October 7, 2003
Subject: South Portland
Project No. STP-9467 (00)X
PIN 9467.00
Bid Amendment No. 1

Add the attached 3 page "Special Provision 608 – Detectable Warnings (Masonry Pavers)" dated October 7, 2003.

Add the attached one page Detail Sheet entitled "Views and Details Of The Detectable Warning".

VIEWS AND DETAILS OF THE DETECTABLE WARNING

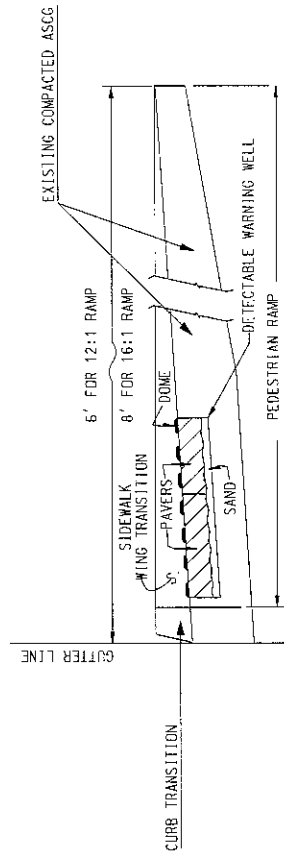
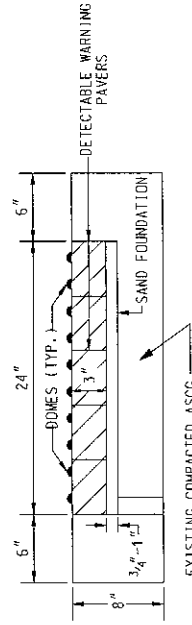
NOTE:
ALL DETECTABLE WARNING AREAS SHALL START 6 INCHES
FROM THE FLOW LINE OF THE CURB, AND BE 24 INCHES
IN DEPTH, AND COVER THE COMPLETE WIDTH OF THE RAMP
AREA ONLY.
